Solicitation Addendum

Addendum No.: 2
Solicitation No.: 18-TA002764JP
Project No.: 6086160
Solicitation Title: Rye Road Functional Improvements and Master Lift Station
Addendum Date: June 11, 2018
Procurement Contact: Joe Pretorius, johannes.pretorius@mymanatee.org

STRUCTURAL REHABILITATION EYE ROAD BRIDGES @ MULL CREEK BRIDGES #134025 & #134026

RYE ROAD BRIDGES
OVER MILL CREEK
STRUCTURAL REHABILITATION

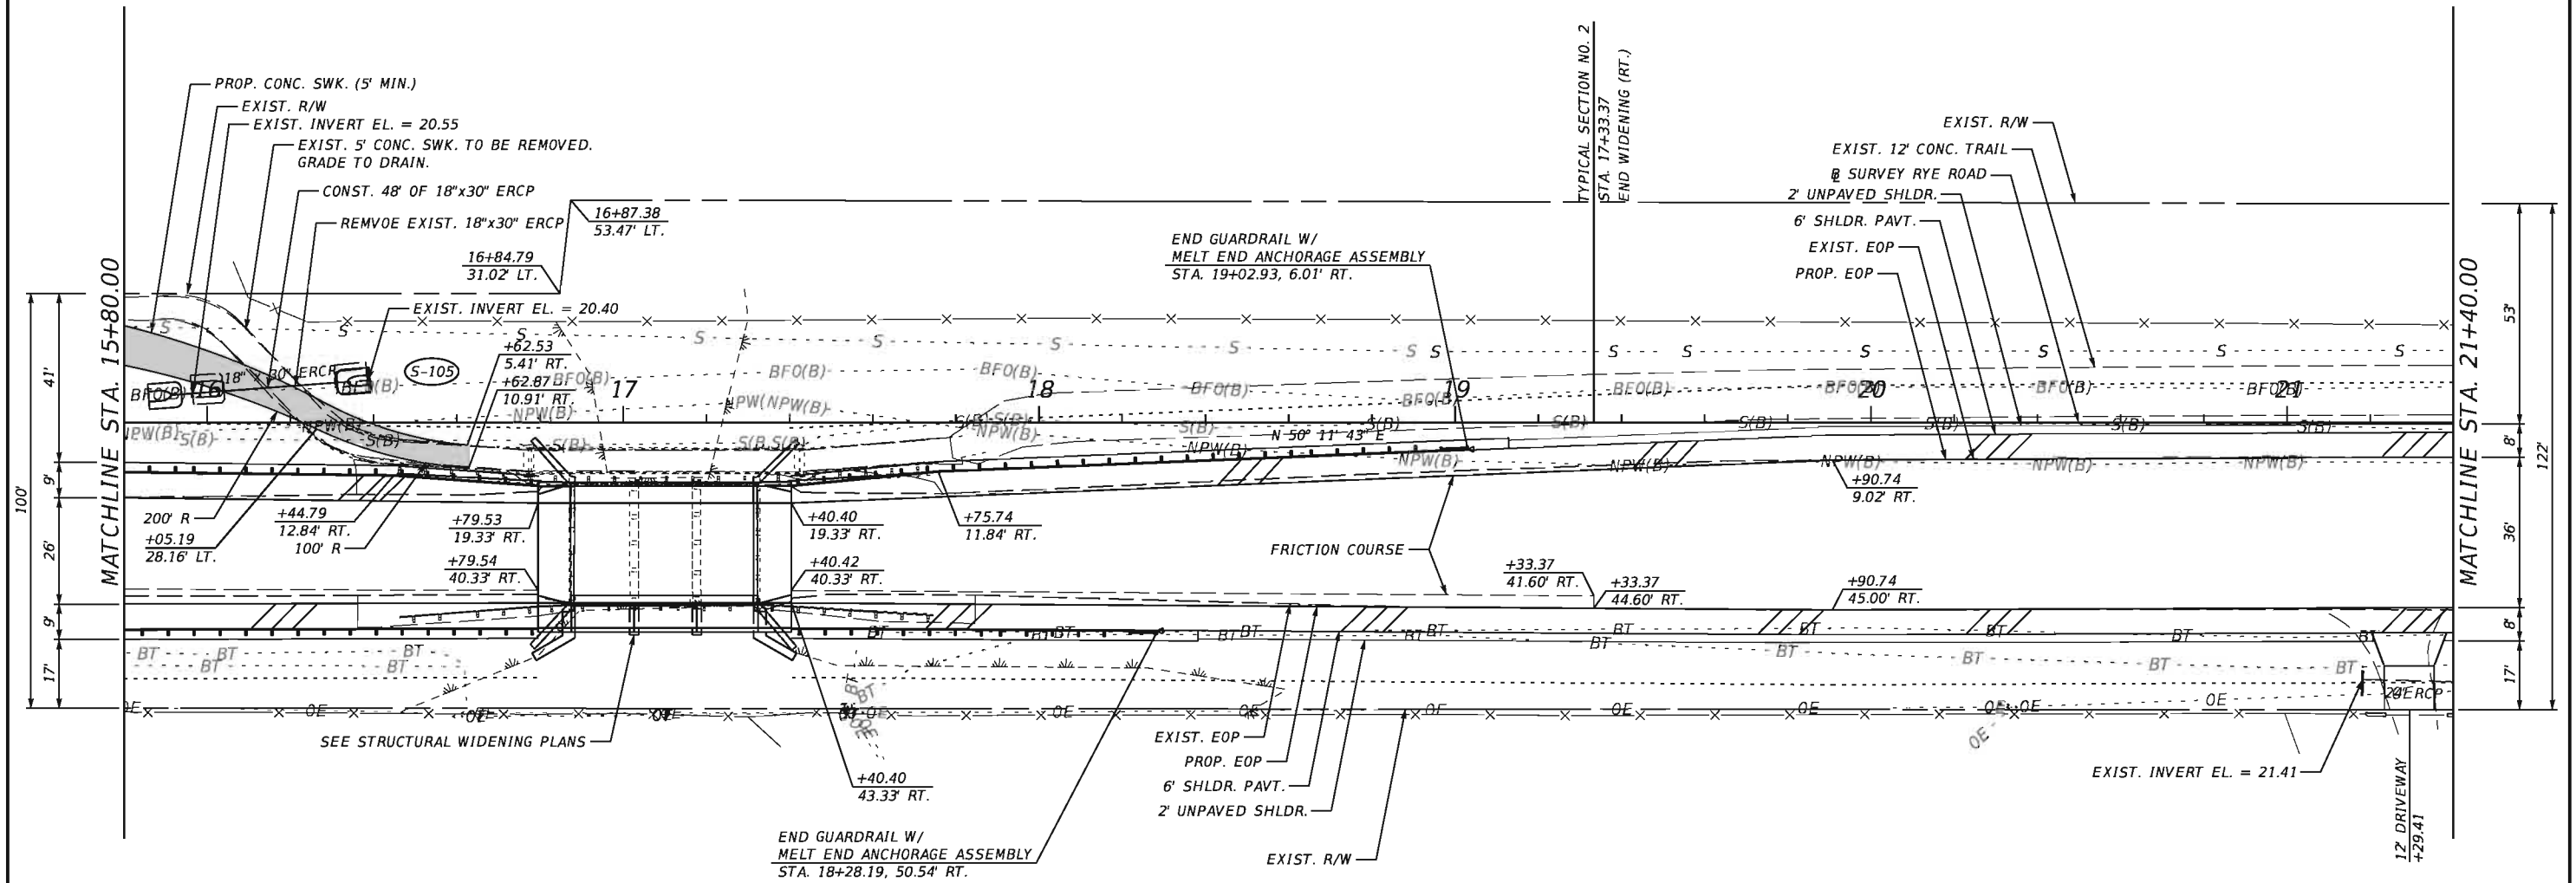
17. Sheet No. 25 - Roadway Plan (17) – Existing pipe sizes added [Question 18]
18. Sheet No. 26 - Roadway Plan (18) – Existing pipe sizes added; removal of existing pipe added [Question 18]

Q18. Referencing the General Notes, note #10 states, "All existing drainage structures, underdrain systems, ditches and ponds are to remain unless otherwise noted". There are no call outs for any of the existing drainage pipe to be removed where it appears that the pipe should be removed. How do we determine what is to be removed and what is not? Please clarify.

Q23. Referencing guardrail: Plan sheet 26 shows the guardrail to tie into the structure walls at all 4 corners. However, there is no pay item 536-8-13 for this work. Shall the item be included in item 536-1-1 or will pay item 536-8-13 be added to the bid form for this project?

R18. Where new sidewalk construction / excavation impacts existing drainage pipes, the intent is to remove the existing pipes. Removal callout notes have been added to the plans per this Addendum No. 2.

R23. The plan sheets showing the bridges refer to the Structural Widening Plans and the three-beam railing with the FDOT 2016 Index 470 / 471 callouts in several locations. There is no need for an additional pay item with the quantity update for 536-1-1.

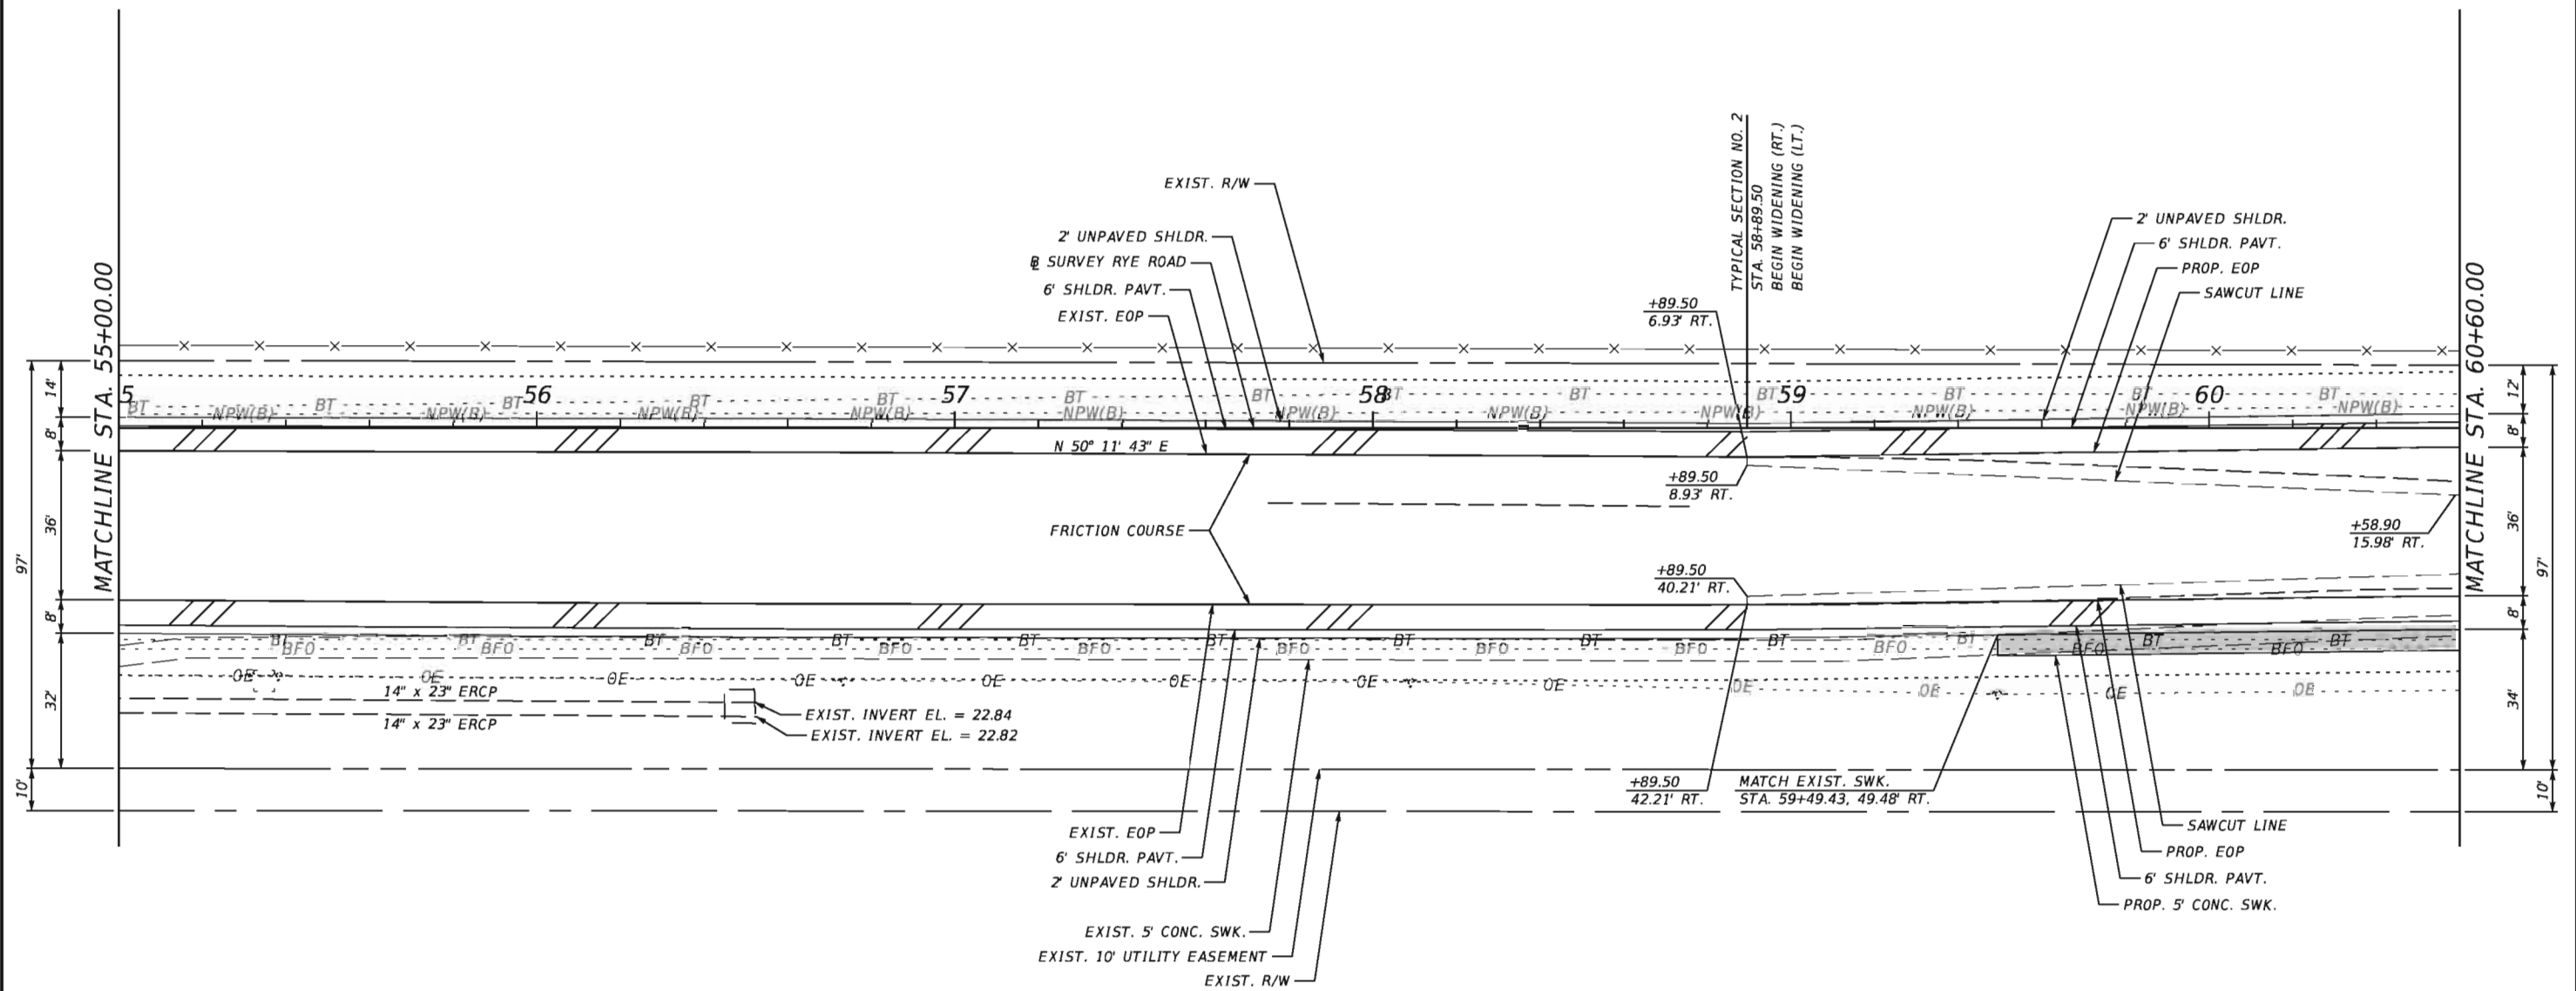
19. Sheet No. 33 - Roadway Plan (25) – Existing pipe sizes added [Question 18]
20. Sheet No. 34 - Roadway Plan (26) – Existing pipe sizes added [Question 18]

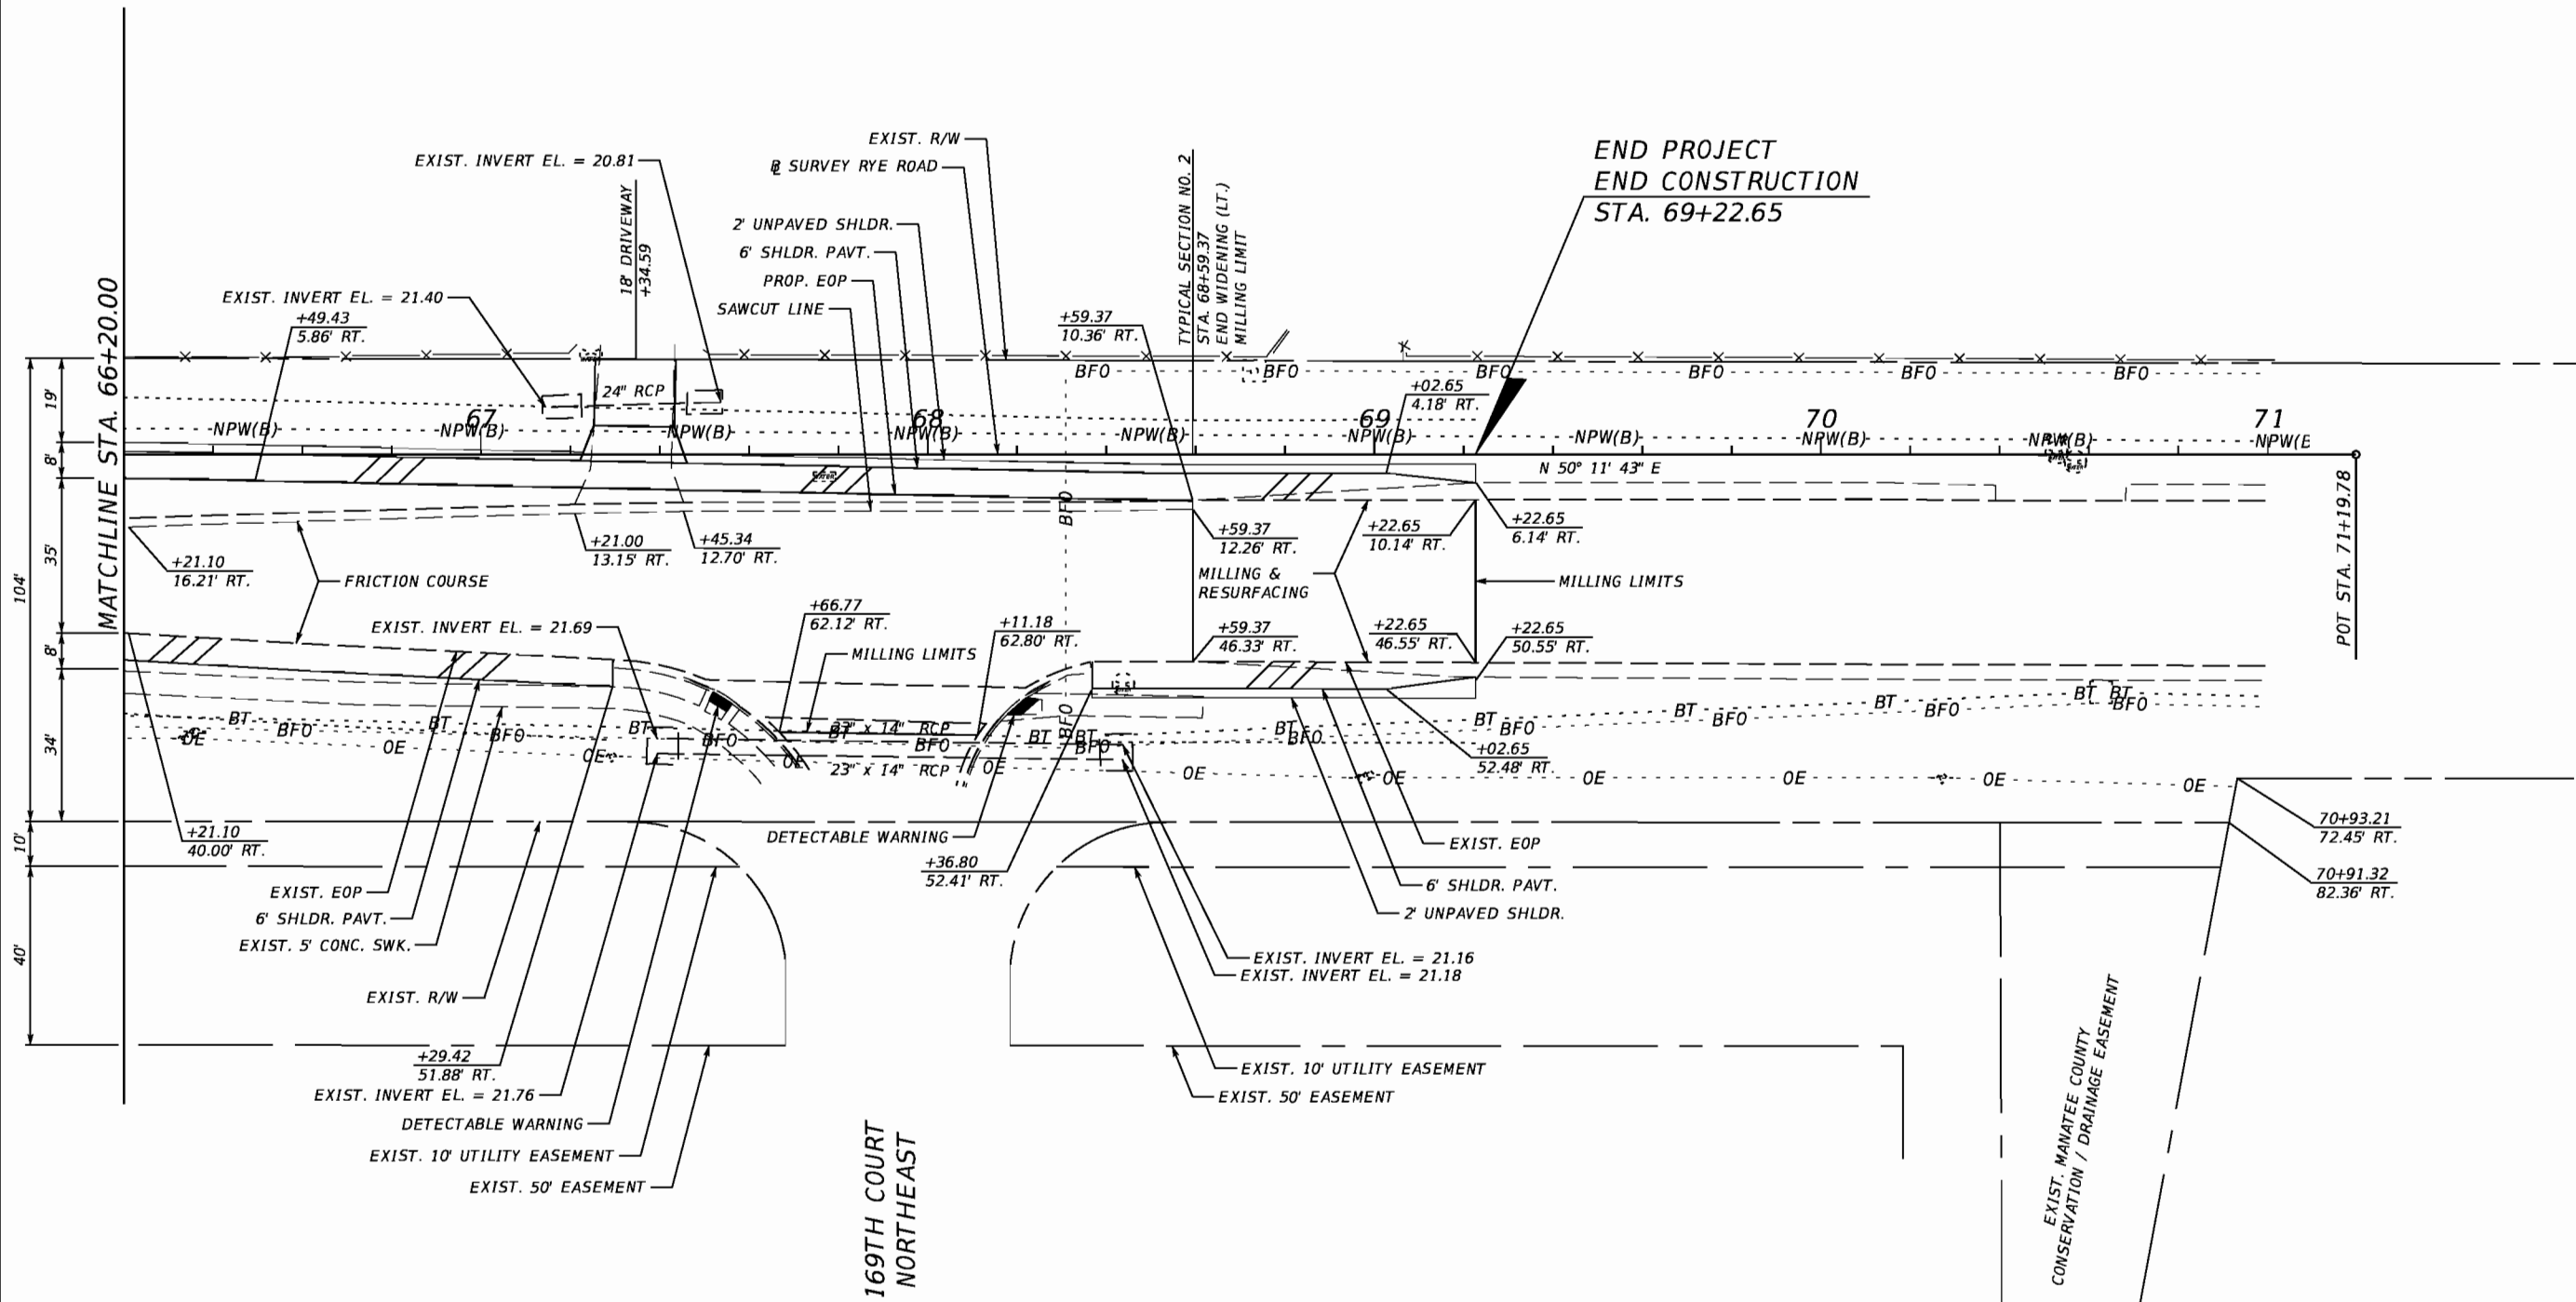
21. Sheet No. 35 - Roadway Plan (27) – Existing pipe sizes added [Question 18]
22. Sheet No. P-2 – General Notes – Design Truck updated [Question 16]

TYPICAL SECTION

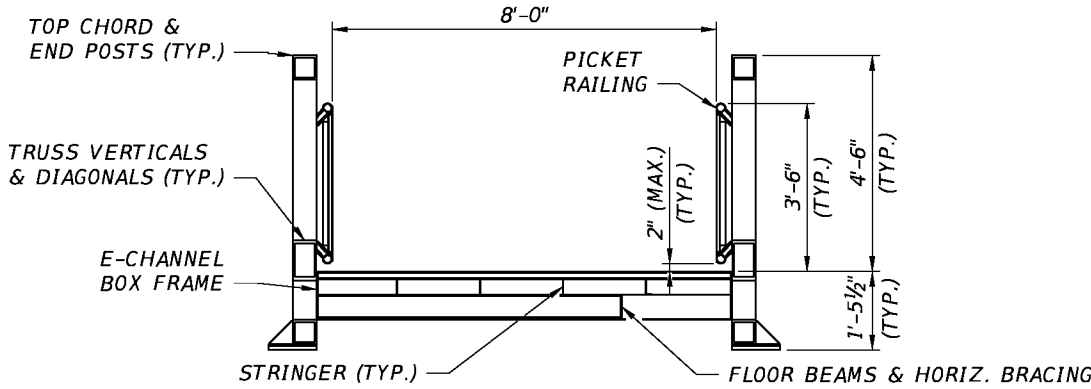
Q16. The pedestrian bridge design loading is calling for H5 Loading. Is this correct, as it seems heavy and is expensive? Please clarify.

R16. The design loading has been revised per this Addendum No. 2 to represent a 2,500 LB utility vehicle with 60% of the load acting upon the rear axle and 40% on the front axle.
